Federal Register

[Docket No. 2000–SW–60–AD]

Airworthiness Directives; Bell Helicopter Textron, Inc., Model 412 Helicopters

ACTION: Notice of proposed rulemaking (NPRM).

FIGURE 1

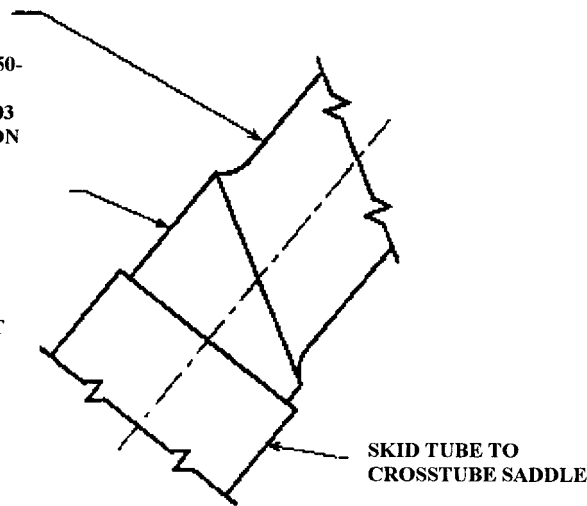
(3) Vibro-etch the P/N on the crosstube assembly adjacent to the skid tube saddle in accordance with Figure 1 for any crosstube assembly not displaying a visible P/N. Identify the crosstube assembly as P/N 412-050-011-107 FM.

(4) Vibro-etch a serial number (S/N) on the crosstube assembly below the P/N in accordance with Figure 1. The S/N must be unique for each crosstube assembly.

VIBRO-ETCH 412-050-011-107 FM
AND A COMPANY CONTROLLED
S/N IN THIS AREA AS REQUIRED
TO TRACK REMAINING HIGH AFT
CROSSTUBE LIFE. VIBRO-
ETCHING DEPTH SHALL NOT
EXCEED 0.005 INCH.
